Informal document **GRE-88-24**
(88th GRE, 25-28 April 2023,
agenda item 6 (a))

Revised proposal for a new series of amendments to UN Regulation No. 48

Submitted by the International Association of the Body and Trailer Building Industry

Figure 1

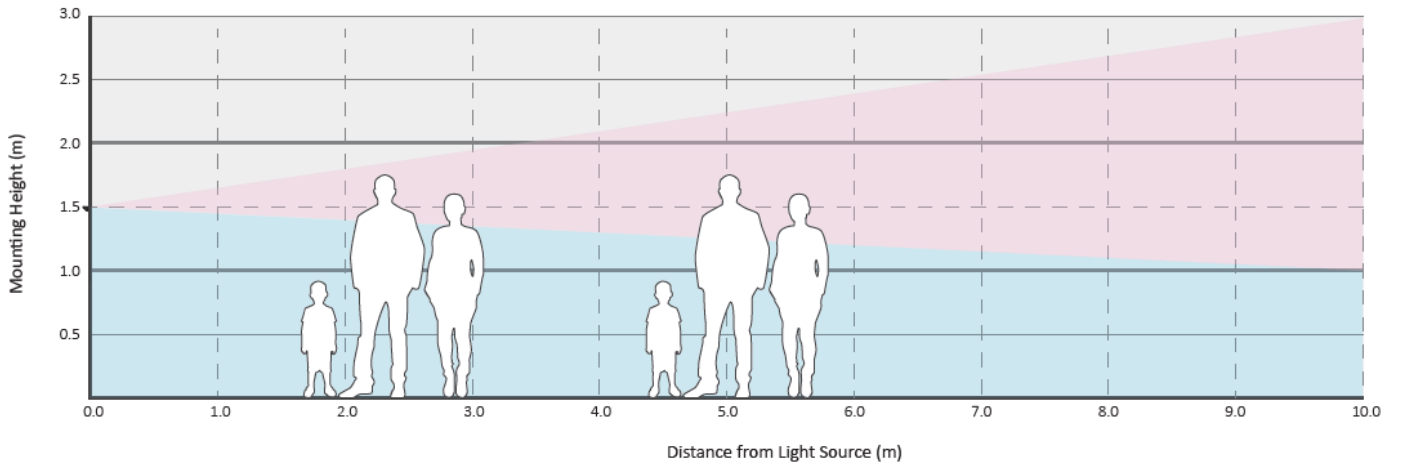
3. As the number of lamps has been increased to a maximum of 3 per side, the installation height has been limited to 1.5 m to avoid the risk of glare to other road users. This also aligns with the maximum height for the installation of side-marker lamps. It should be noted that the observation area of manoeuvring lamps must also meet the requirements of Annex 14 (see Figure 1 below for an illustration of the maximum, worst-case condition).
